AN ORDINANCE GRANTING APPROVAL OF A SPECIAL USE AUTHORIZING A MAJOR CHANGE TO THE MARKETPLACE OF ROLLING MEADOWS PLANNED DEVELOPMENT AUTHORIZED BY ORDINANCE 00-16 FOR LOT 5, APPROVAL OF PRELIMINARY AND FINAL PLANSTO REDEVELOP THE SITE WITH A NEW 3,077 SQUARE FOOT RAISING CANES RESTAURANT WITH DRIVE-THROUGH, INCLUDING VARIATIONS AND OTHER EXCEPTIONS AND ZONING RELIEF

RE: PUD Amendment
Raising Cane's C0837 – Golf & Meijer
1420 Golf Road
Rolling Meadows, IL 60008

**Ordinance Exhibit 3
Staff Review Letters**

Planning and Zoning Commission Review
Sign Package – Raising Cane's
1420 Golf Road

CUTSHEET
 Monument
 LOCATION TBD
 5' FROM FRONT AND CORNER LOT LINE, 10" FROM ANY INTERIOR SIDE LOT LINE
 MAX HEIGHT 8', 100 SF
 PLANNED DEVELOPMENT AMENDMENT REQUIRED

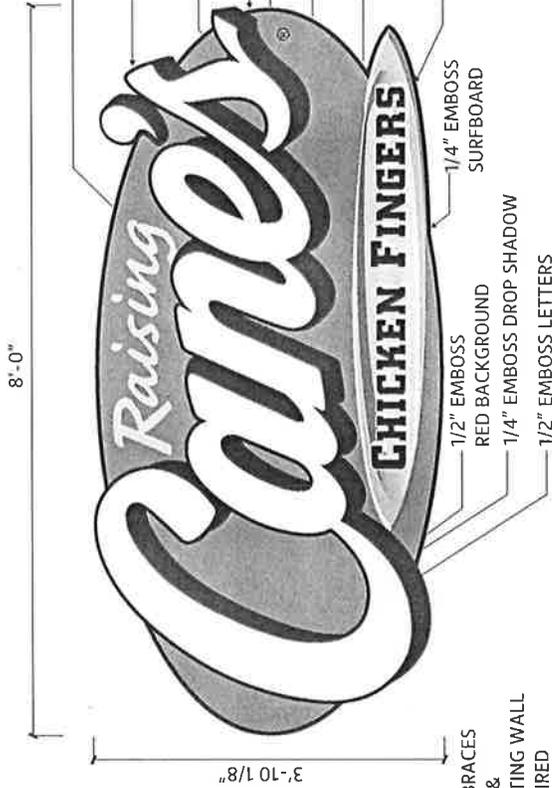
2. As part of site engineering plans, a landscaping plan will be required. That landscaping plan shall include landscaping around the base of the monument sign for a radius of at least three feet, as required by the zoning code. [122-606(d)(3)]

WS-8FT

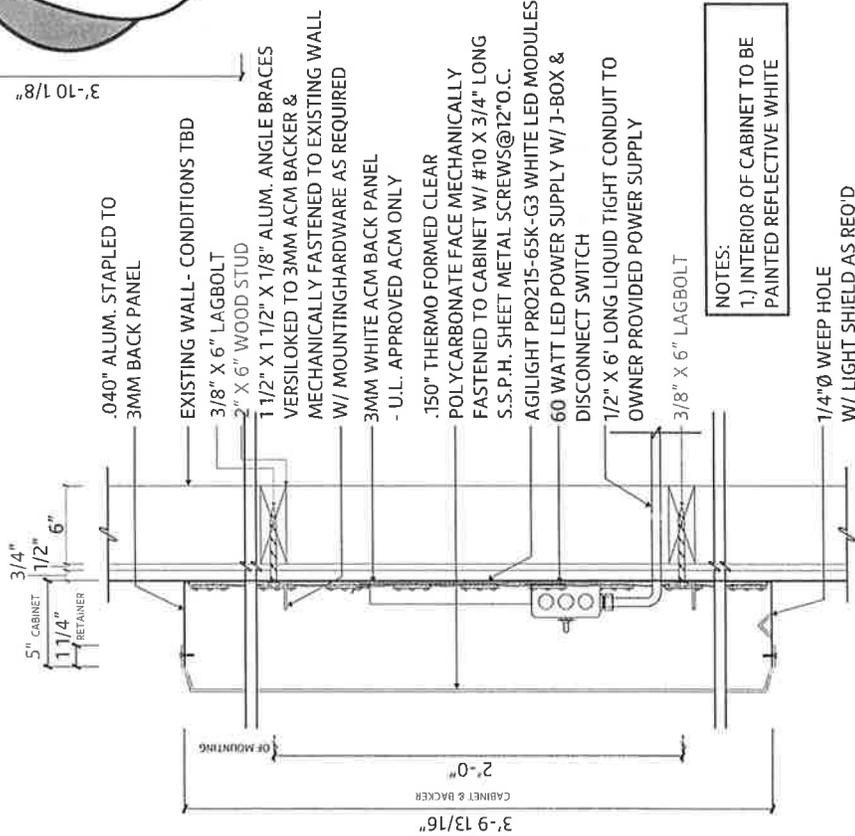
1 WS ALLOWED ON FRONT ELEVATION & 1 ADDITIONAL SIGN ALLOWED ON A SECOND ELEVATION
ALL ADDITIONAL SIGNAGE MUST BE ADDED TO THE PLANNED DEVELOPMENT AMENDMENT

3. Per the zoning code, two wall signs are allowed for a building with a single occupant. The two additional wall signs will require a variance from the code as part of the Planned Development Amendment. Staff is supportive of this variation. [122-606(f)]

PHOTOMETRIC SITE PLAN
 SCALE: 1/4" = 1'-0"
 N

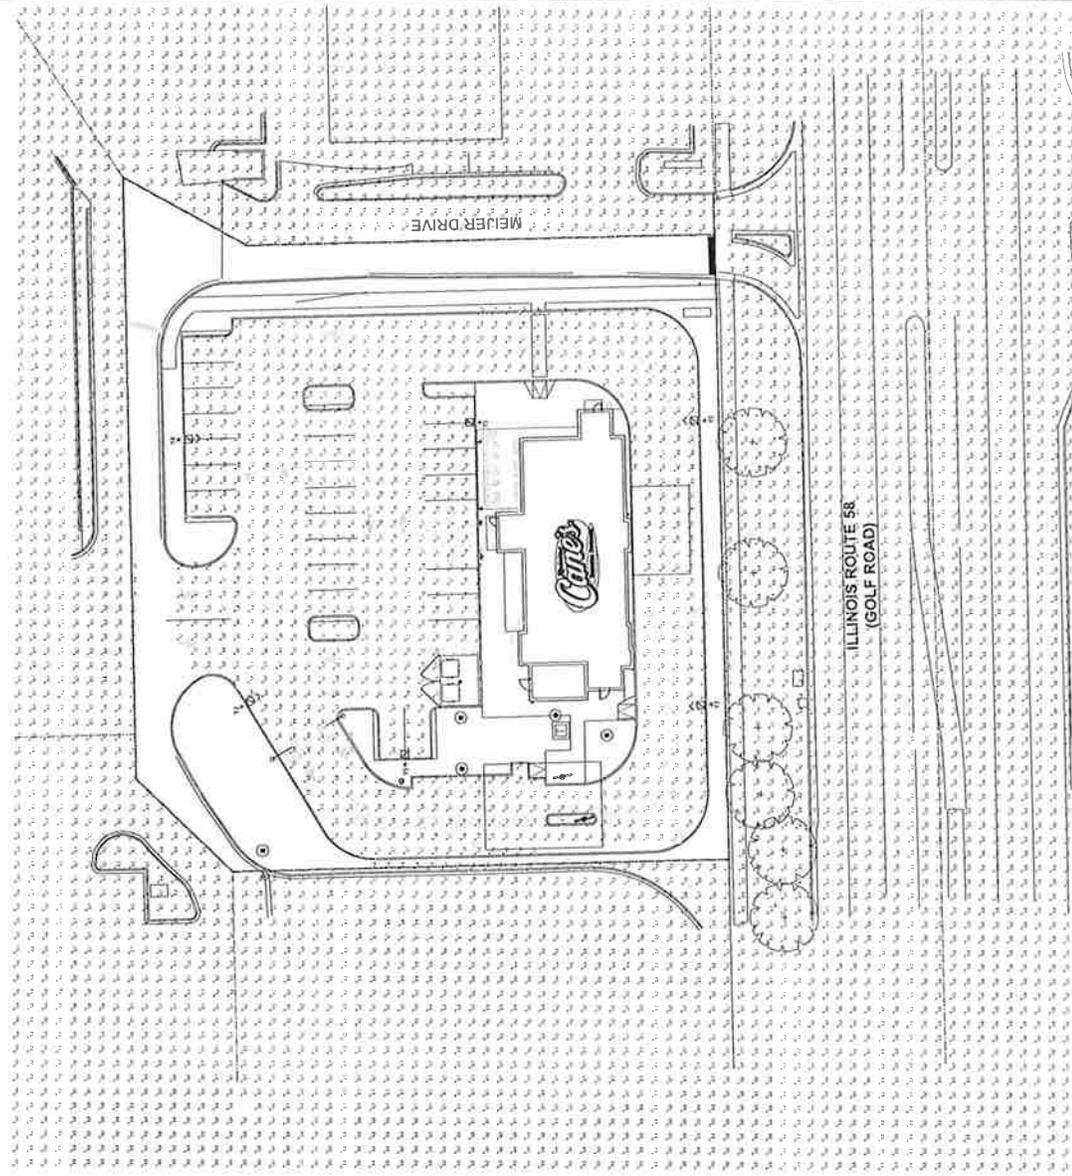
5. In the luminaire schedule indicate the tilt (referenced above horizontal) for all fixtures to verify that fixtures have a zero degree tilt and so as not to project glare to roadways or neighboring properties.

6. In the luminaire fixture schedule indicate the arm length used for each fixture.
 7. Provide a manufactures catalog cut of all proposed poles and luminaires.

8. There is an existing light pole at the northwest corner of the site that appears to serve the east-west drive just adjacent the north side of the property. This pole appears to be in conflict with the proposed sidewalk. If it is proposed to be moved or removed, photometrics will need to be provided to ensure the drive will be properly lit. Provide the status of this light pole?
